PETITION FOR GRANT OF LOCATION

PETITION TO INSTALL NEW JO POLE and REPLACE AND RELOCATE JO POLE

Proposed Poles – P1065 and P1064 on North Street

(NATIONAL GRID PLAN #: 31339564)

PETITION SKETCH

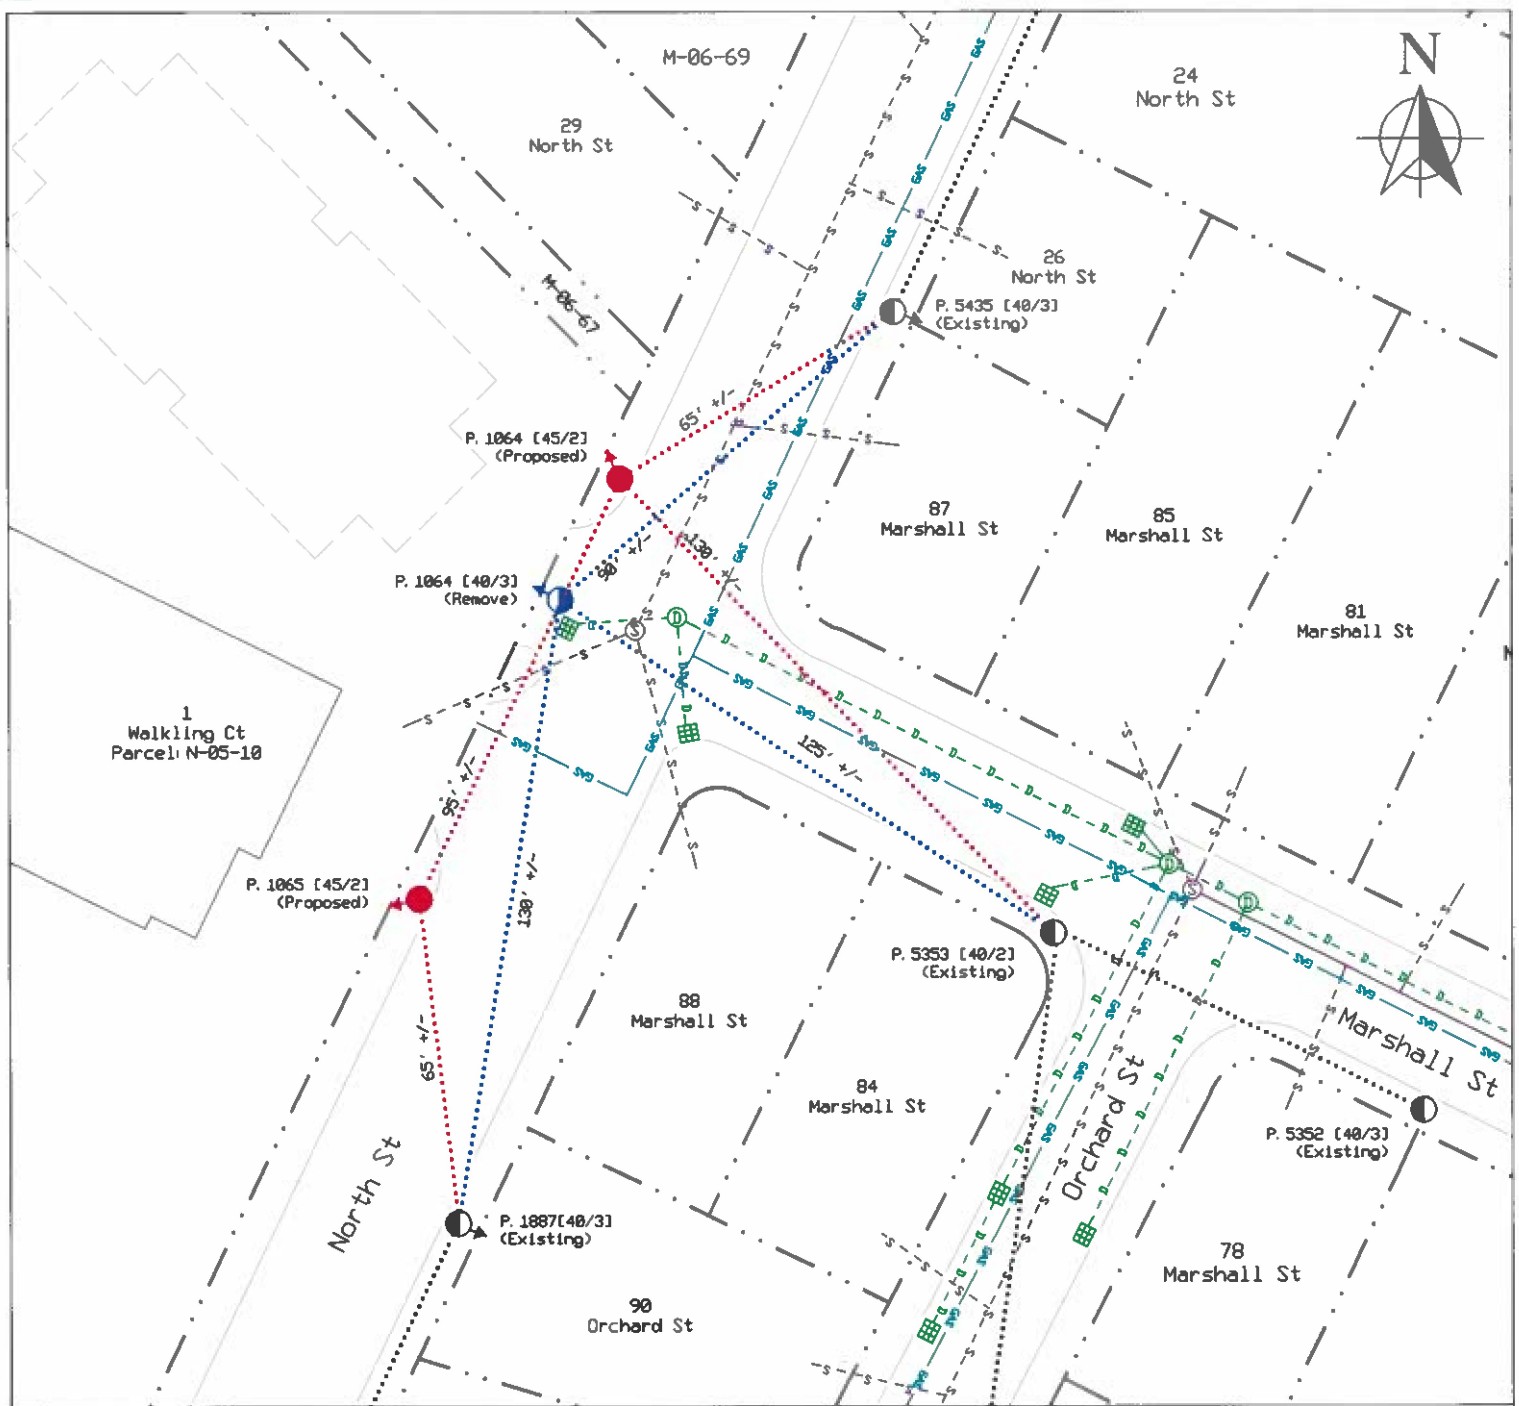
1. The Grant of Location (GOL) is limited to the addition of one joint owned utility pole located within the cement concrete sidewalk at the existing entrance to the Walkling Court Development on North Street and labeled P-1065 (Proposed) as depicted on the Sketch.

2. The GOL is conditioned on the removal and replacement of one existing joint owned pole currently in the North Street ROW and labeled P-1064 (Removed) as depicted on the sketch and replace the relocated pole 30-feet to the north and labeled P-1064 (Proposed).

5. Placement of the joint owned utility pole must be within the 'furniture' zone and provide at least forty-inch (40") clearance of accessible travel path around the structure in accordance with ADA regulations and City standards. The placement of the joint owned utility pole must be no closer than 6-inches from the back of granite curb.
